**DATE:** March 21, 2014  
**SUBJECT:** Oquirrh Mountain  
Marketplace – Site Plan -  
Review #3

**FROM:** Damir Drozdek, Planner II

DATE: February 5, 2014  
SUBJECT: Oquirrh Mountain  
Marketplace – Site Plan -  
Review #2

**C1.01**  
 HORIZONTAL CONTROL PLAN  
 DATE: MAR. 04, 2014  
 CHECKED BY: TJD  
 DRAWN BY: JHF  
 PROJECT NO: 13493 A

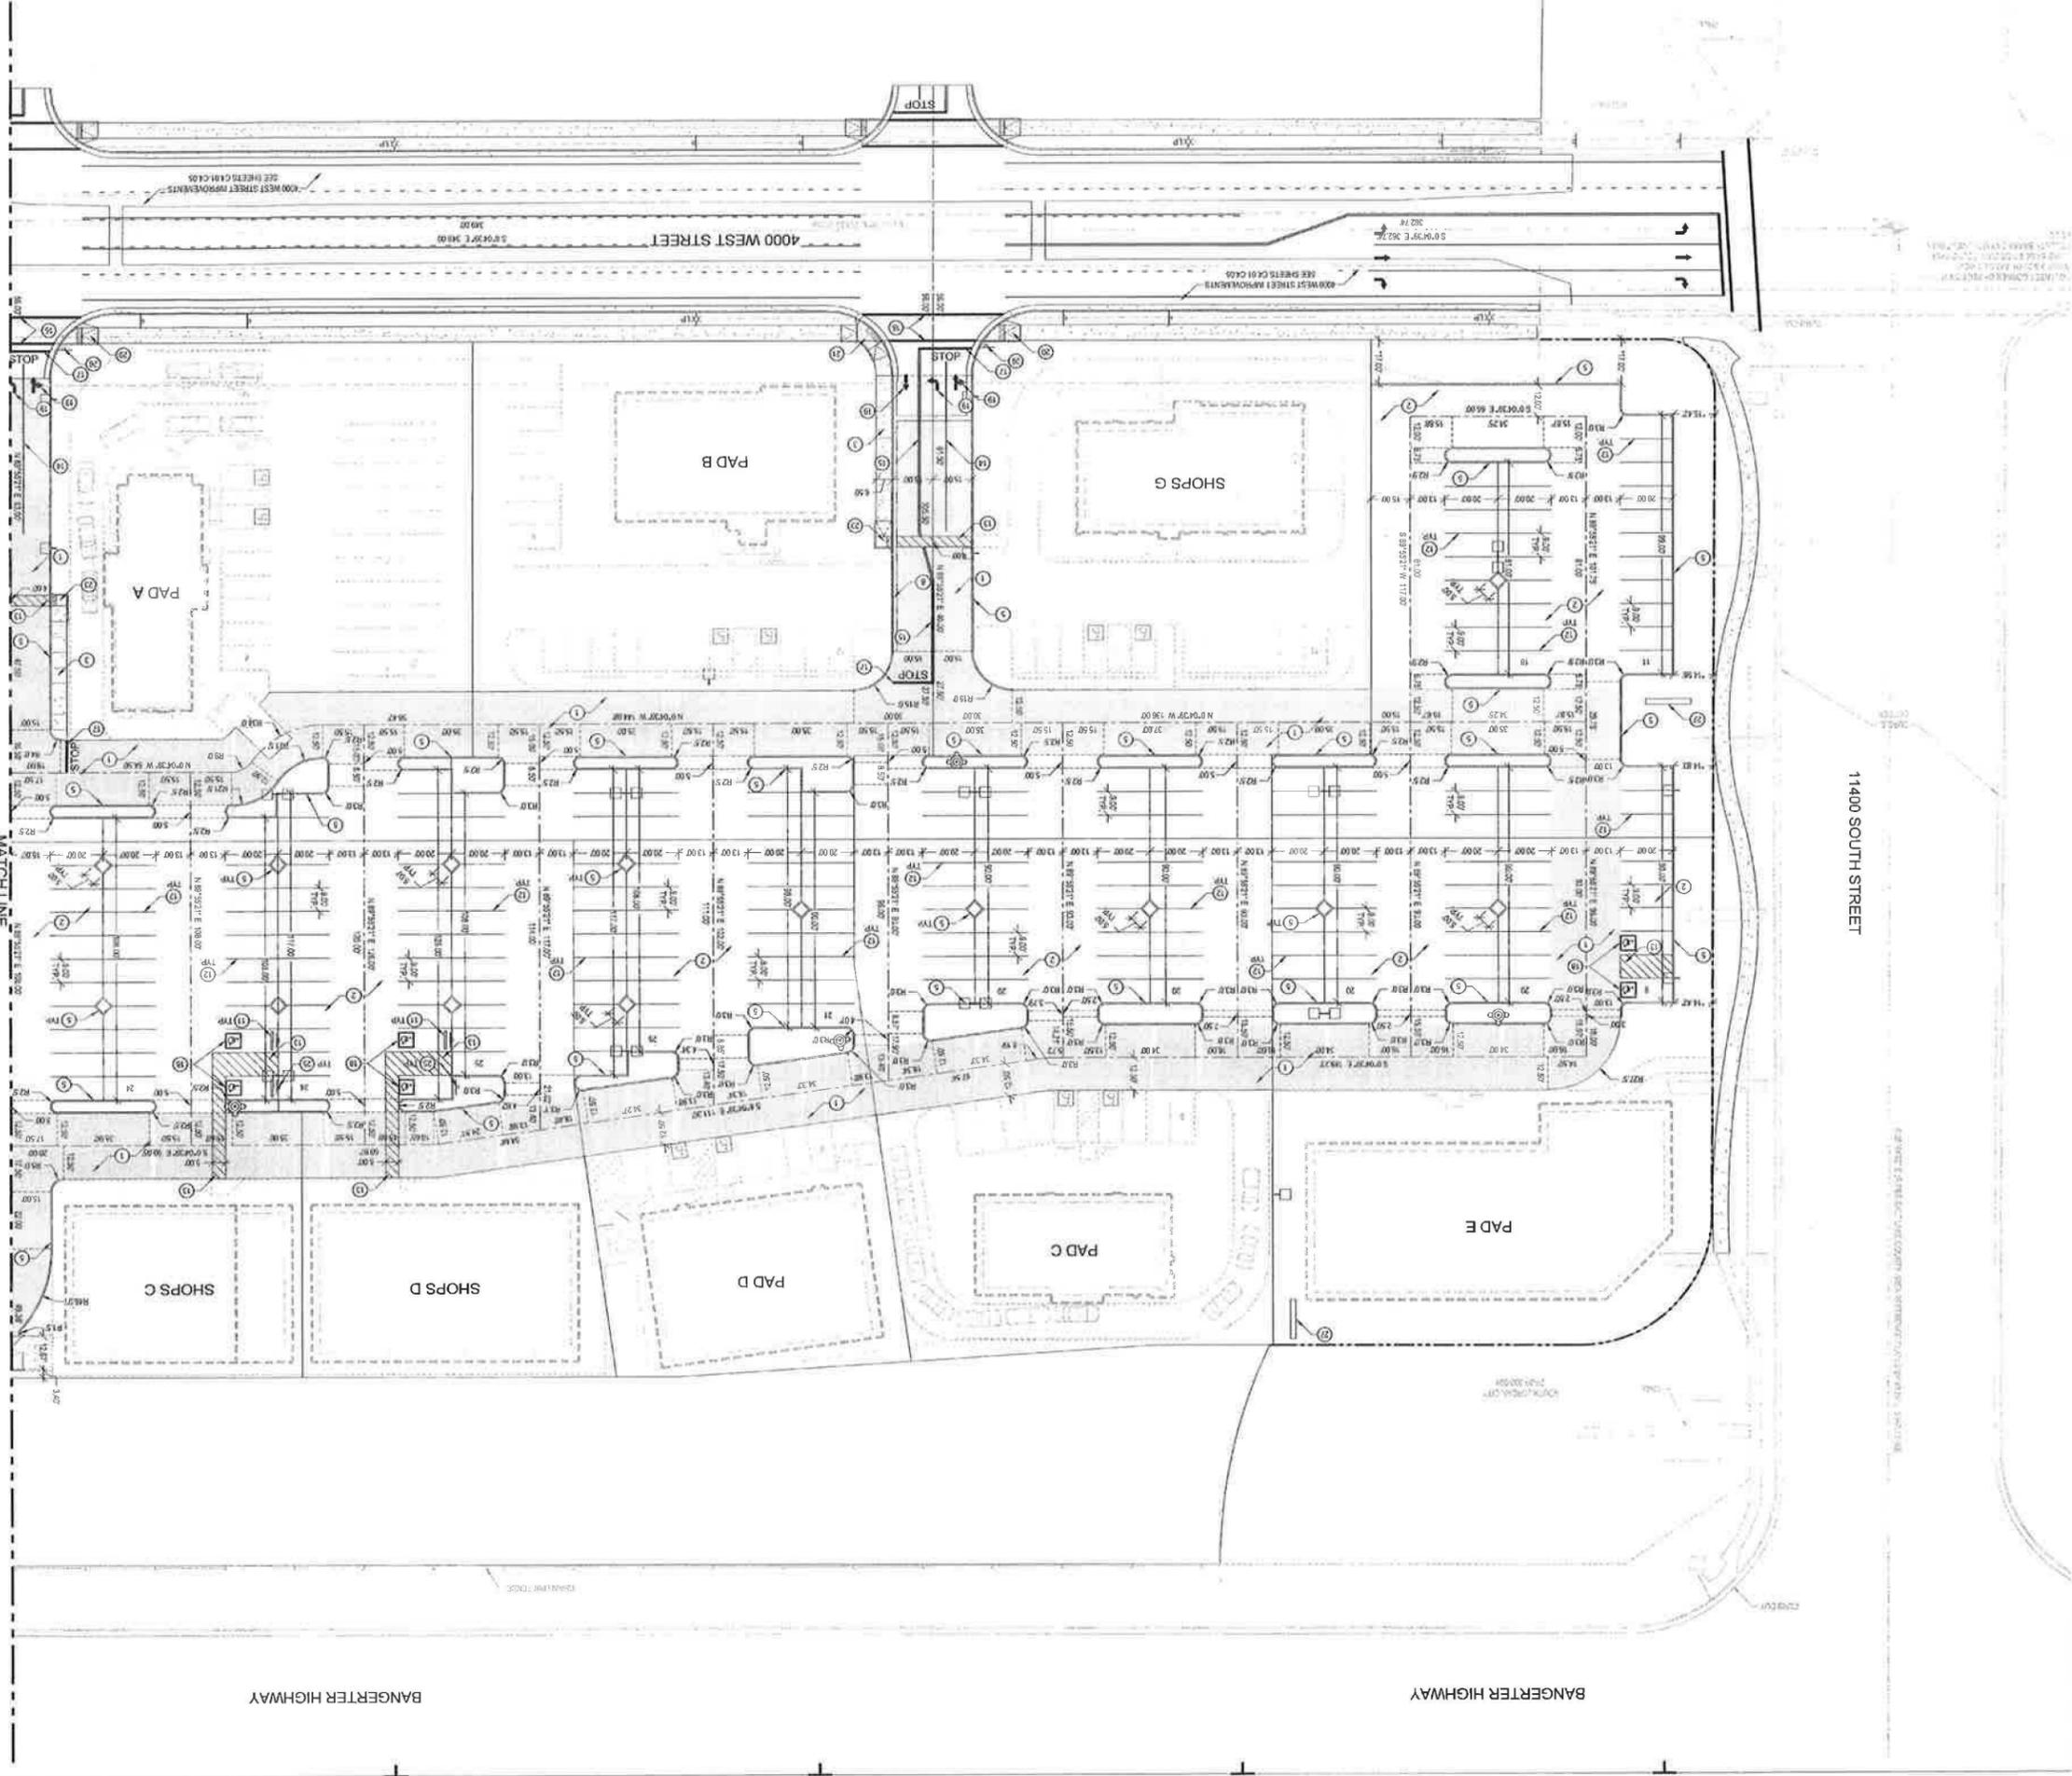
#### Horizontal Control Plan C1.01

**HORIZONTAL CONTROL PLAN**  
C1.02

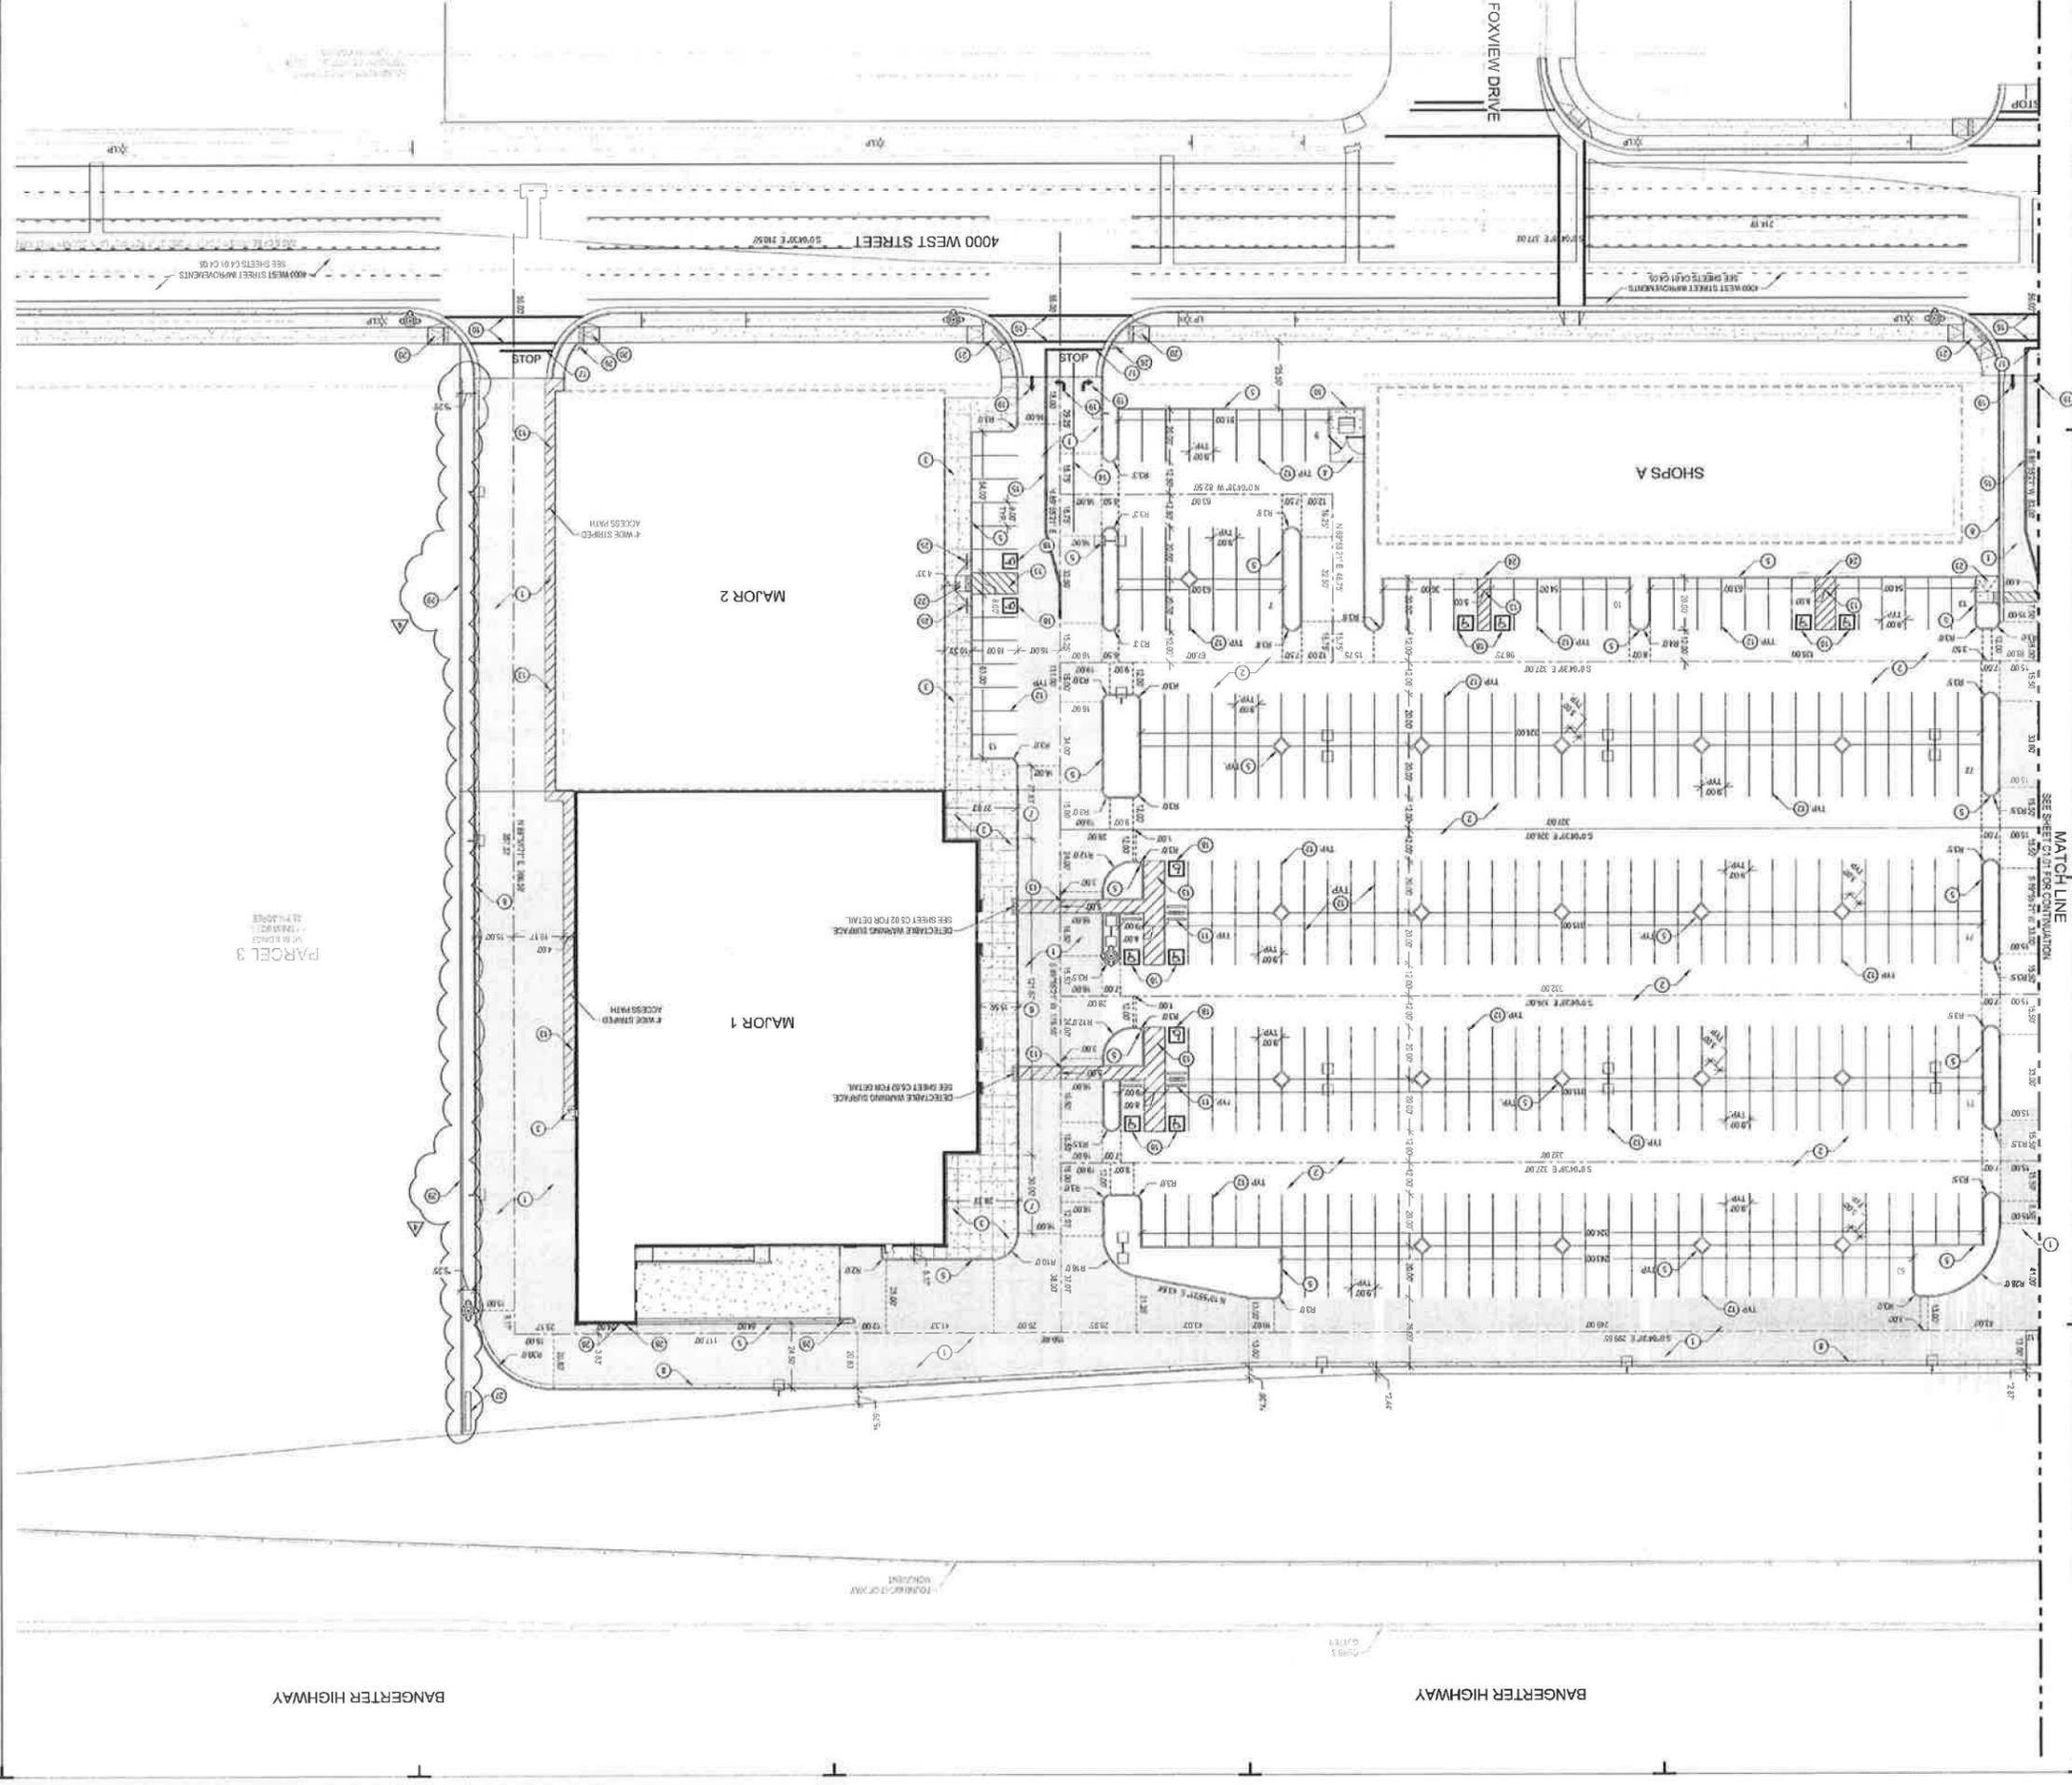
5. ADA ramps are missing in the front of the Sprouts store. Why is there an ADA ramp in front of major 2 but no ramps in front of major 1?
6. See comment #4.
